ACCESSIBILITY CHECKLIST

DEPARTMENT OF REHABILITION

4930 W KAWEAH COURT SUITE 100 VISALIA, CA 93277

RESD PROJECT #139602

(AA1) CONFERENCE/JOB CLUB

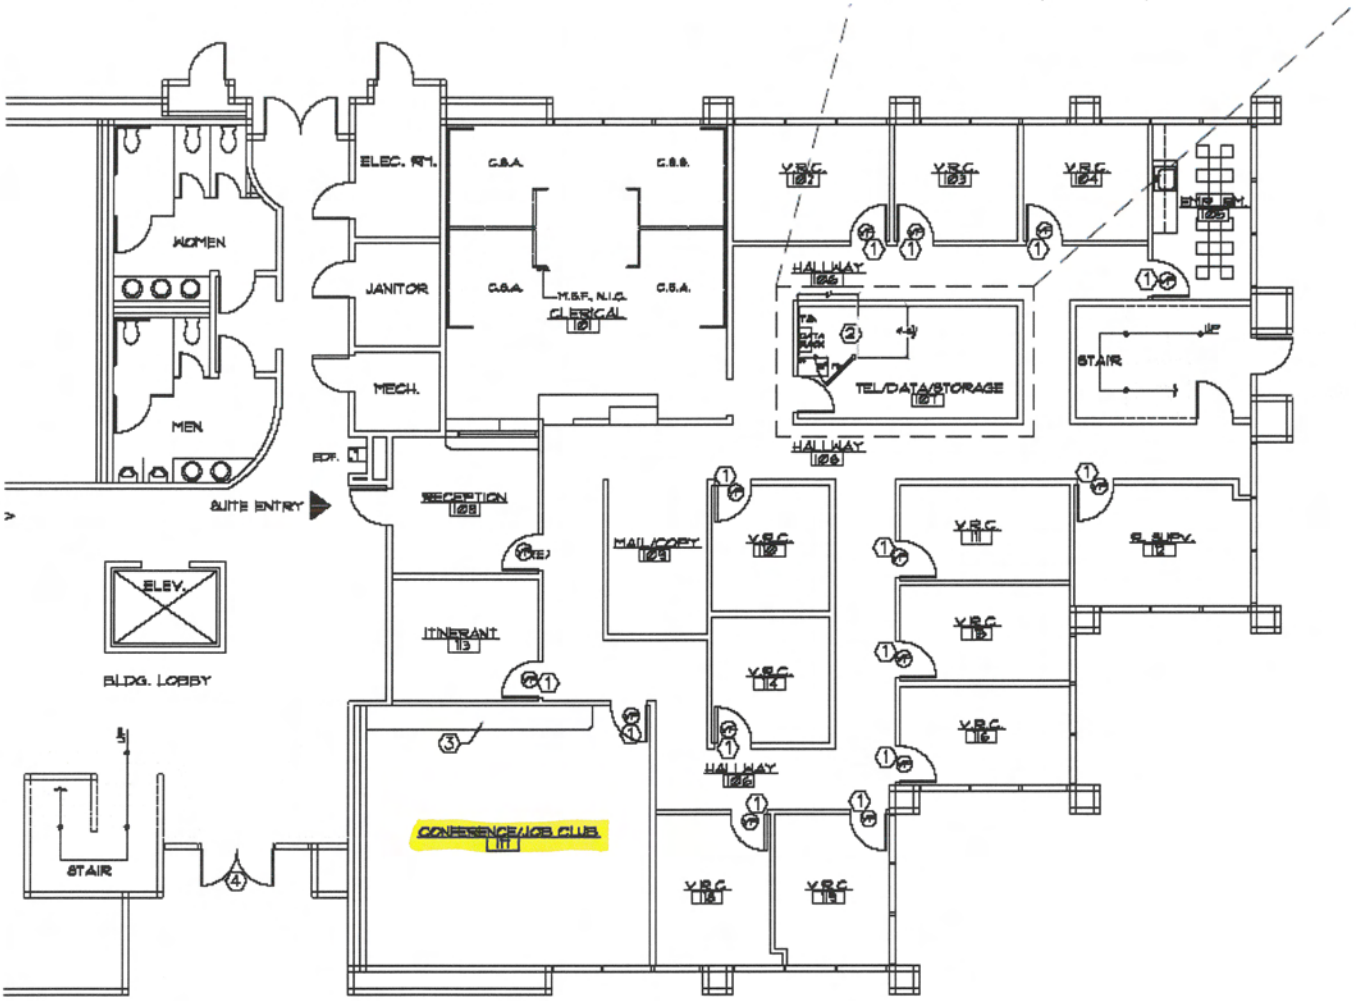
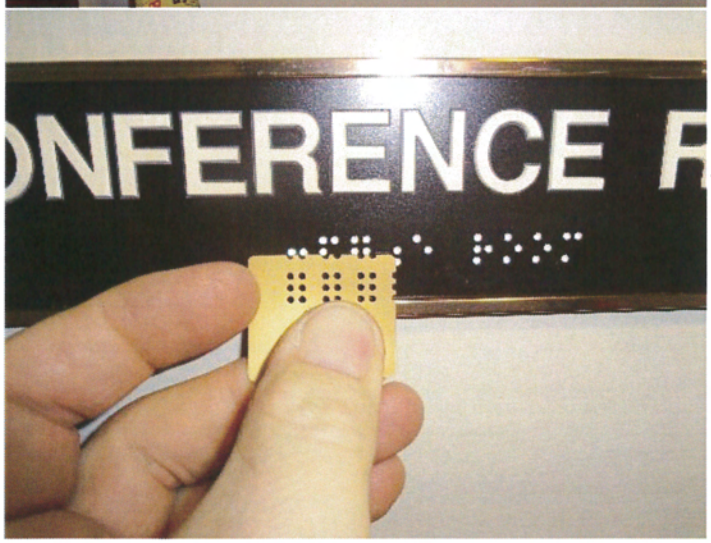
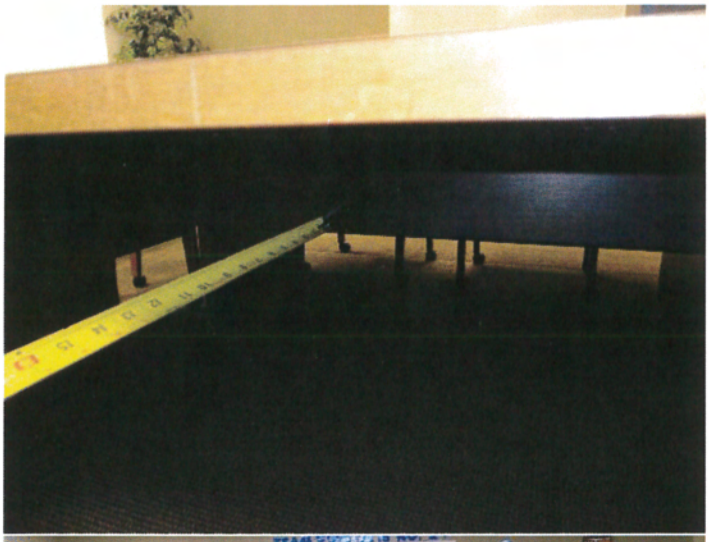
15.8B	Mounting Location	Are tactile signs mounted on the wall adjacent to the latch side of the door 48" min from baseline of lowest Braille to 60" max AFF from baseline of highest line of raised characters? For double doors with one active leaf, is the sign located on the inactive leaf? For double doors with both active leafs, is the sign located to the right of the right hand door? If there is no wall space, is the sign located at the latch side of a single door or at the right side of double door on the nearest adjacent wall? 11B-703.4.1 Figure 11B-703.4.1, 11B-703.4.2			Yes ☐ No ■ N/A ☐
